**Siu Ho Wan Depot Property Development  
EP-588/2021 – Siu Ho Wan Station and Siu Ho Wan Depot Replanning Works  
Condition 2.15 – Landscape and Visual Plan**

**Siu Ho Wan Station and  
Siu Ho Wan Depot Replanning Works**

Deliverable Nos. 3.34B & 7.40B  
Detailed Landscape and Visual Plan

C1701-P-SHD-OAP-230-000004

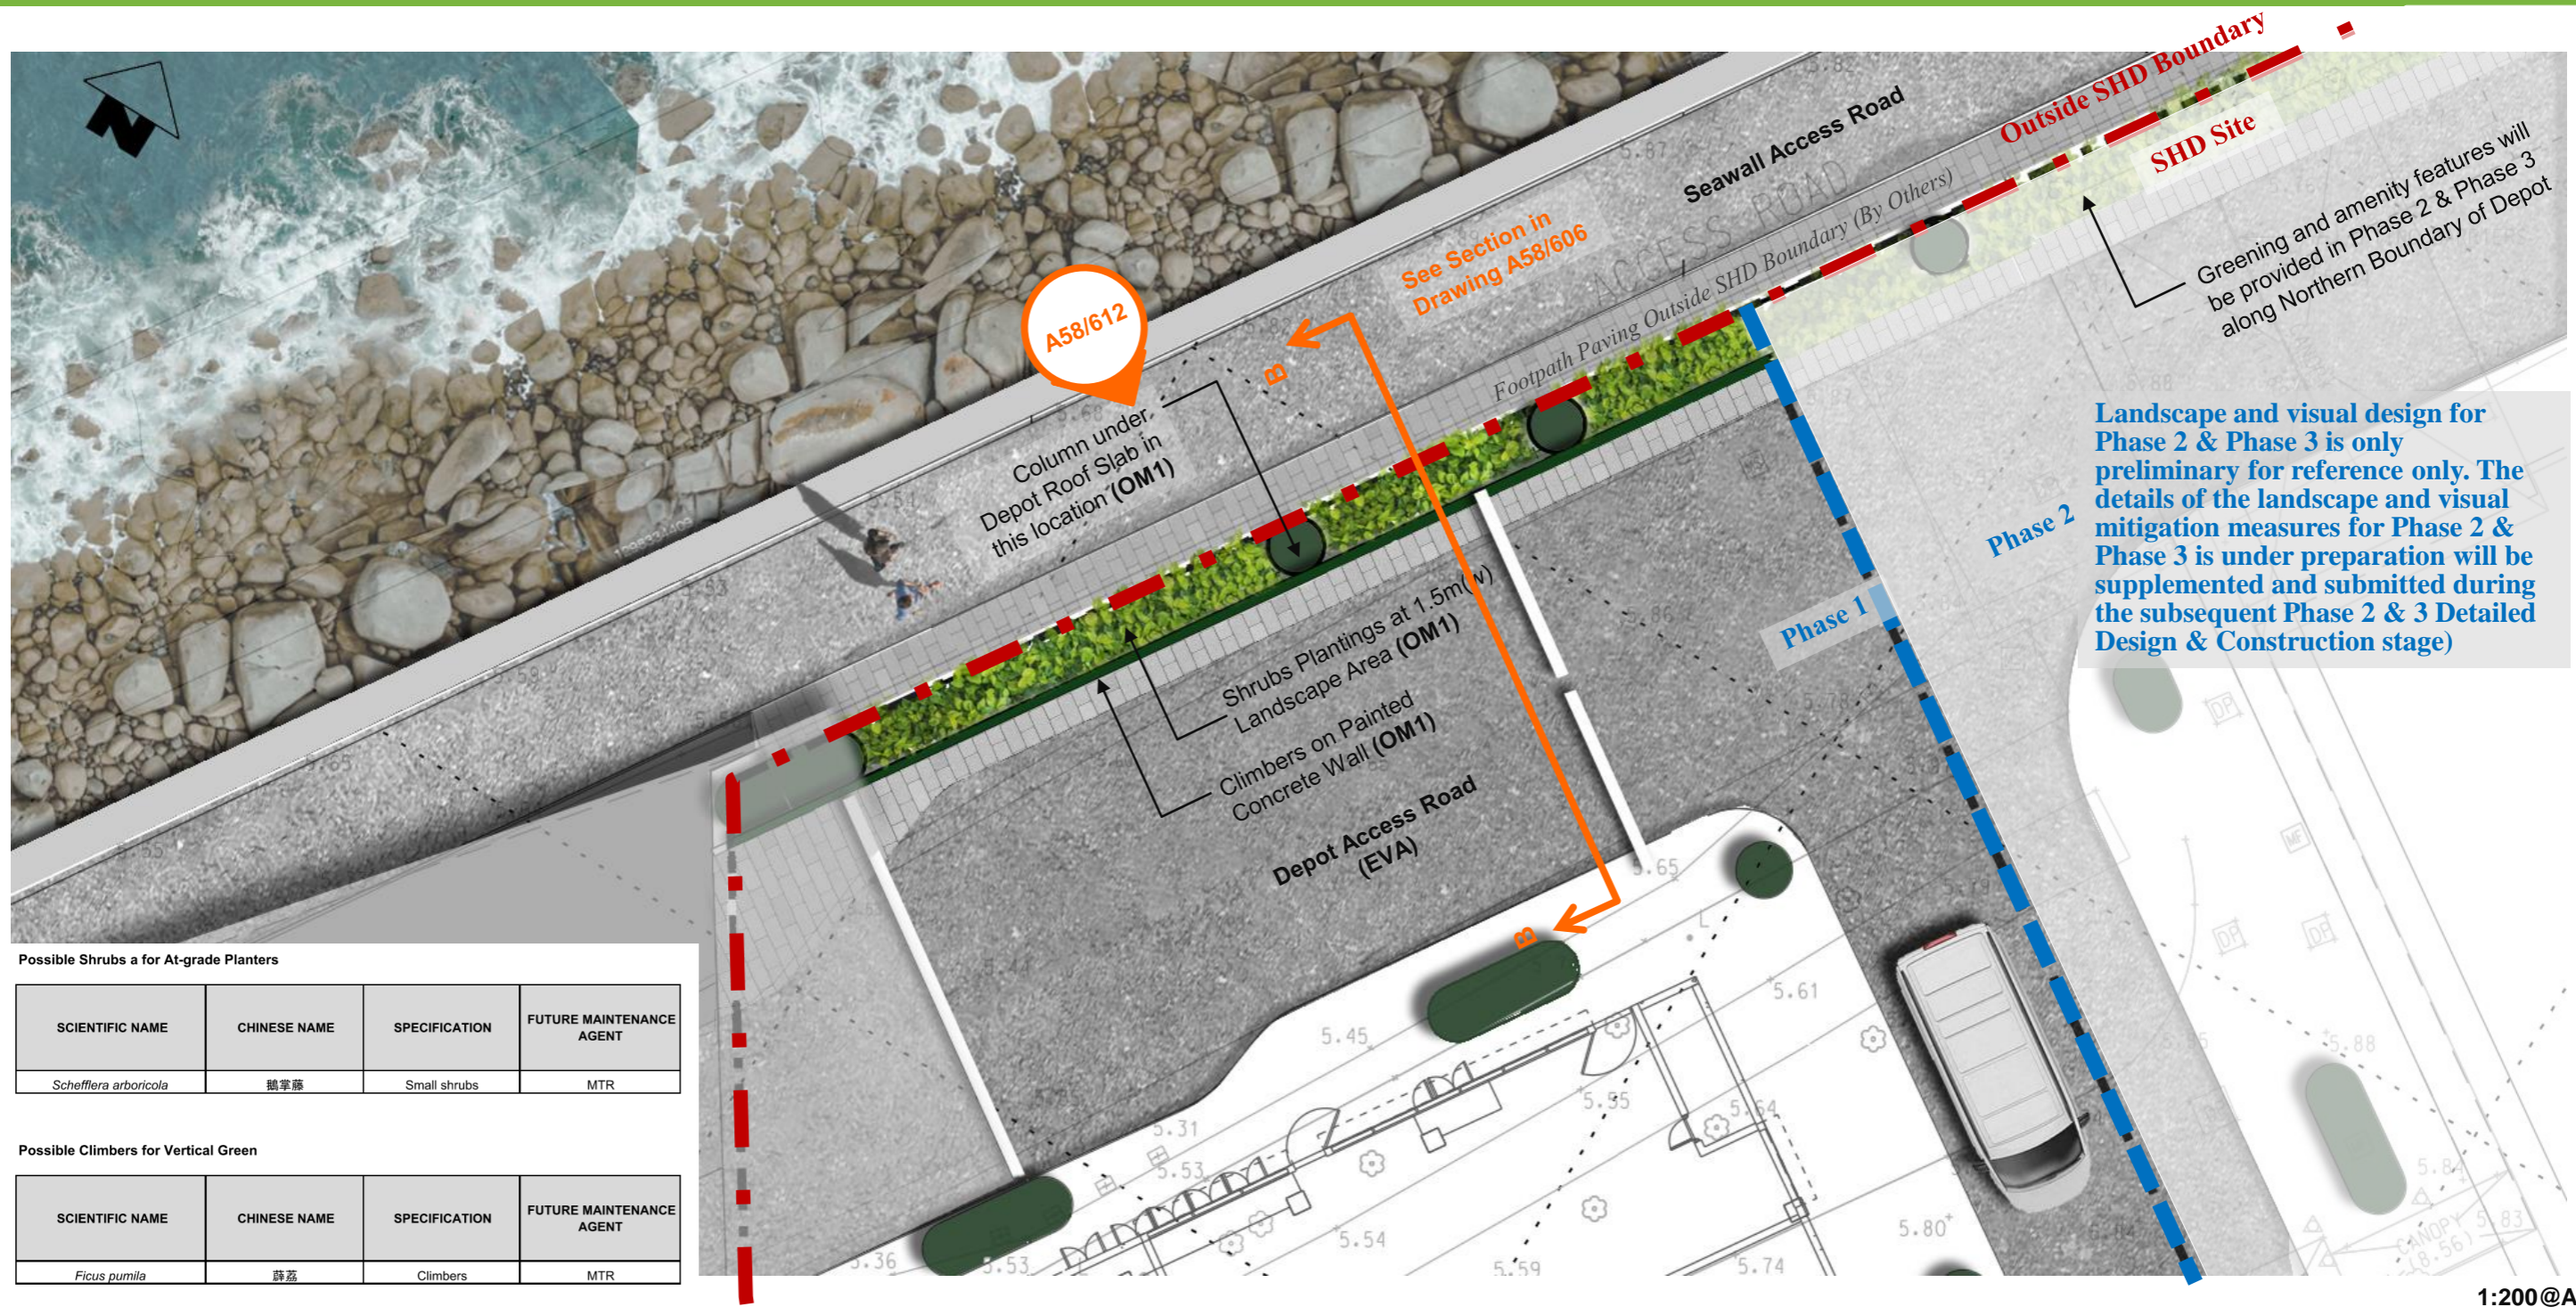
ID No.	Section	Comments	Responses
		<p><b>From: Mr. Patrick Wong, EPD</b>  <b>Ref : ( ) in EP2/N9/A/163 Pt.4</b>  <b>Date: 7 September 2023</b></p>	
		<p>I refer to the letter dated 27 July 2023, submitting the Landscape and Visual Plan (the LVP) of the Project pursuant to Condition 2.15 of EP No. EP-588/2021. Please find our comments for you to follow up.</p>	<p>Noted.</p>
		<p>It is noted from S.1.3.2 that Phase 4 will handled over to Government after completion of Phase 3 and outside the scope of design under the Plan. Having said that, since the purpose of this EP submission is to show the landscape and visual features along the waterfront with a view to minimising the overall landscape and visual impact of the Project. For completeness, the discussion on landscape and visual features for Phase 4 waterfront shall also be included.</p>	<p>Noted. The existing depot facilities at Phase 4 area (Granted to MTR as Lot 146) will be demolished and removed by MTR. MTR shall thereafter deliver the vacant site back to the Government after existing depot facilities are wholly relocated to redeveloped SHD area by Year 2039. The Phase 4 area re-development will be carried out by the Government and will no longer be part of the SHD re-development project.</p>

- Please note that the scheme does not include soft landscaping for Phase 4 as this is outside the scope of work under this consultancy. The orange hatch area shown in Phase 4 of SHD, showing the possible area for landscape intent only. **The existing depot facilities at Phase 4 area (Granted to MTR as Lot 146) will be demolished and removed by MTR. MTR shall thereafter deliver the vacant site back to the Government after existing depot facilities are wholly relocated to redeveloped SHD area by Year 2039. The Phase 4 area re-development will be carried out by the Government and will no longer be part of the replanning works under this EP.**
